2013 Leon Creek Water Recycling Center (WRC) Rehabilitation and Process Improvements

SAWS Job No.: 13-6505

Addendum No. 6

August 24, 2015

Contractual Organizational Structure

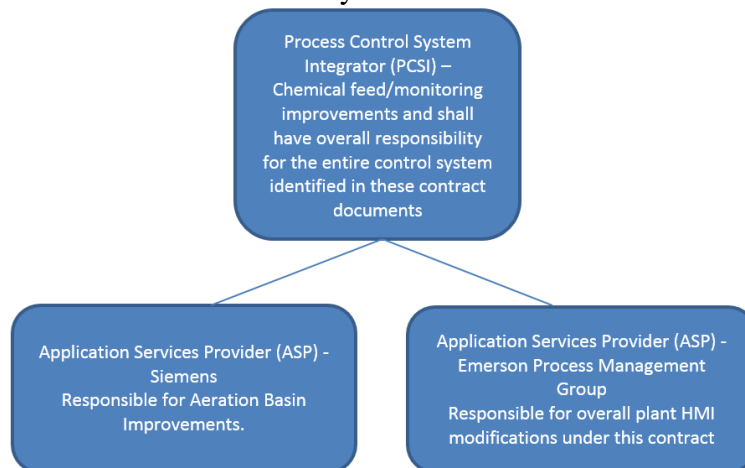
2. Page 1, Paragraph 1.01: Add the following:

C. Contractor shall furnish all labor, materials and services required to install and test equipment supplied by PCSI and ASPs (Aeration Basin blower system and chemical monitoring and feed improvements) identified under this contract. Contractor shall complete this work utilizing a PCSI and two separate ASPs. The contractual organizational structure shall be as illustrated and described below:

1. PCSI shall contract directly with the Contractor and shall be responsible for programming the chemical feed/monitoring system and shall have overall responsibility for the entire control system identified in these contract documents.

2. PCSI shall procure the services of an ASP, which shall be Siemens, for the Aeration Basin Improvements.
 - a. Siemens shall be responsible for commissioning the Aeration Basin Improvements and commissioning communications between the Aeration Basin integration and the ASP providing and developing the Human Machine Interface (HMI) software system, Emerson.

3. PCSI shall procure the services of an ASP, which shall be Emerson, for implementation of HMI modifications for both the Aeration Basin Improvements and the chemical feed/monitoring system.

- a. ASP, Emerson, shall be responsible for commissioning modifications to the HMI and commissioning communications between the PCSI chemical feed/monitoring system and Siemens Aeration Basin control system.
